WRITTEN STATEMENT OF CONDITIONS

The City of North Richland Hills received this plat on April 15, 2024. The Development Review Committee reviewed this plat on April 16, 2024. The following represents the written statement of the conditions for conditional approval of the plat. The applicant may submit a written response and revised plat that adequately addresses each condition.

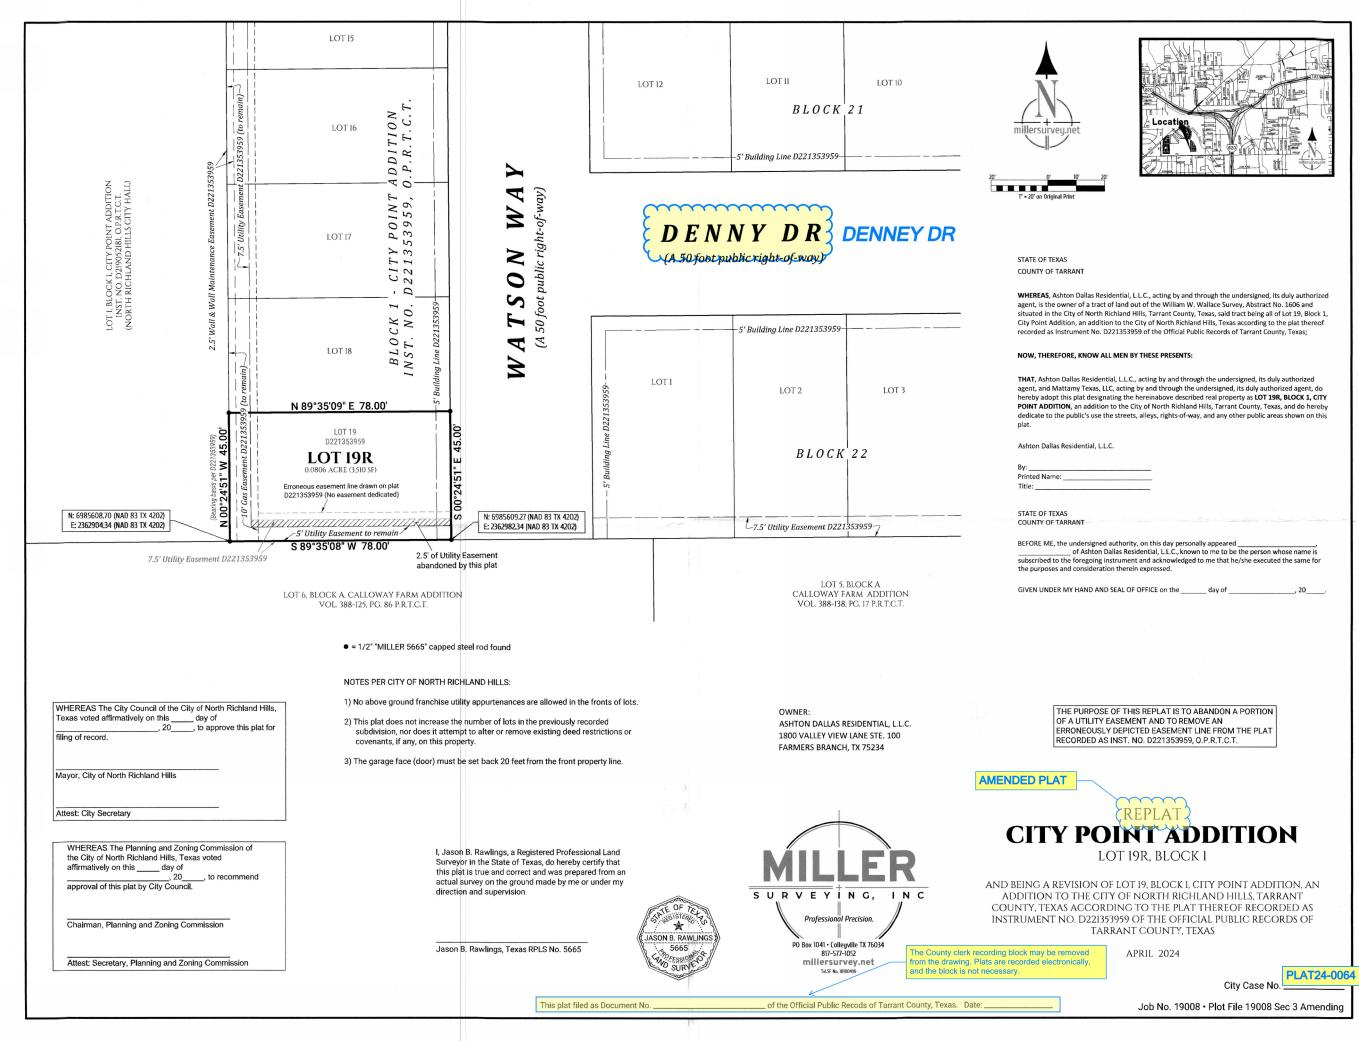
- 1. Update the title block to read AMENDED PLAT rather than REPLAT. NRH Subdivision Regulations §110-331 (Requirements for all plat drawings title block)
- 2. The County clerk recording block may be removed from the drawing. Plats are recorded electronically, and the block is not necessary. NRH Subdivision Regulations §110-333 (Additional requirements for plat drawings county certification)
- 3. Revise the spelling of the street name to **DENNEY DRIVE**. NRH Subdivision Regulations §110-331 (Requirements for all plat drawings street names)

- 1. Add the City case number near the bottom right corner of the drawings (Case PLAT24-0064).
- 2. <u>Informational comments</u>. These comments are informational only and do not need to be added to the drawing.
 - a. Lot 19R will retain its current address of 4201 Watson Way.
